TRANSNUCLEAR WEST  
STANDARDIZED NUHOMS<sup>®</sup> SYSTEM  
NUHOMS<sup>®</sup>-61BT  
DRY SHIELDED CANISTER  
SAFETY EVALUATION REPORT

**SAFETY EVALUATION REPORT  
ADDITION OF THE NUHOMS<sup>®</sup>-61BT DRY SHIELDED CANISTER  
AND ADDITIONAL FUEL TYPES**

**DOCKET NO. 72-1004  
MODEL NOS. STANDARDIZED NUHOMS<sup>®</sup>-24P, -52B, AND -61BT  
TRANSNUCLEAR WEST, INC.  
CERTIFICATE OF COMPLIANCE NO. 1004**

NUHOMS<sup>®</sup>-61BT Dry Shielded Canister  
Figure 1

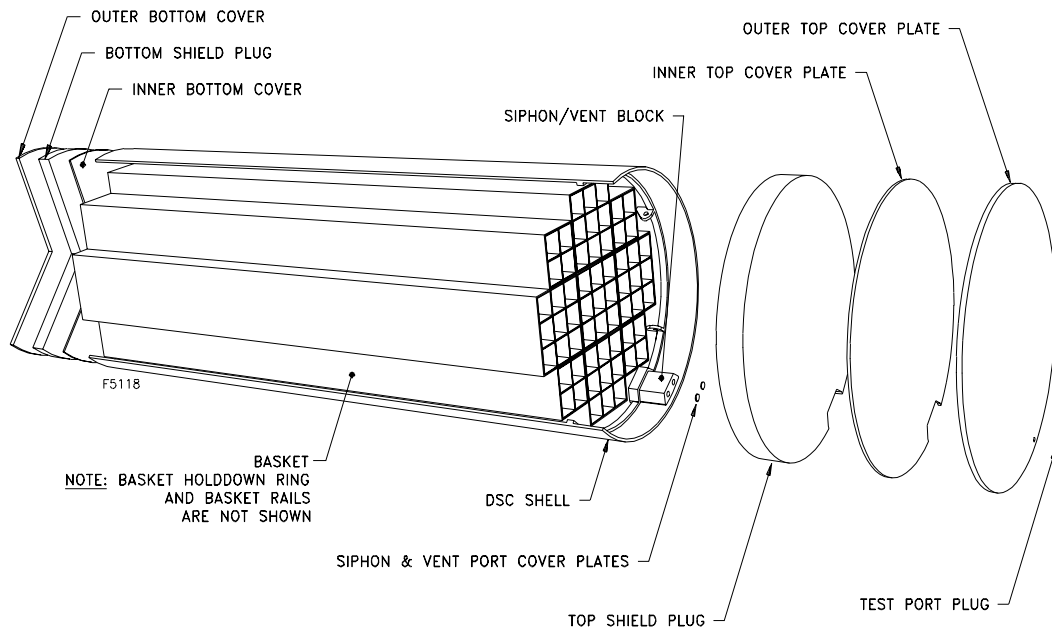
The NUHOMS<sup>®</sup>-61BT DSC, shown in Figure 1, is a new DSC design which consists of a fuel basket and canister body. Borated aluminum, boron carbide/aluminum metal matrix composite, or Boral<sup>®</sup> plates provide criticality control and heat conduction paths from the fuel assemblies to the cask wall. The canister shell thickness has been reduced from the NUHOMS<sup>®</sup>-52B by 0.125 inches to 0.500 inches and the welded closure has been upgraded to leak tight.
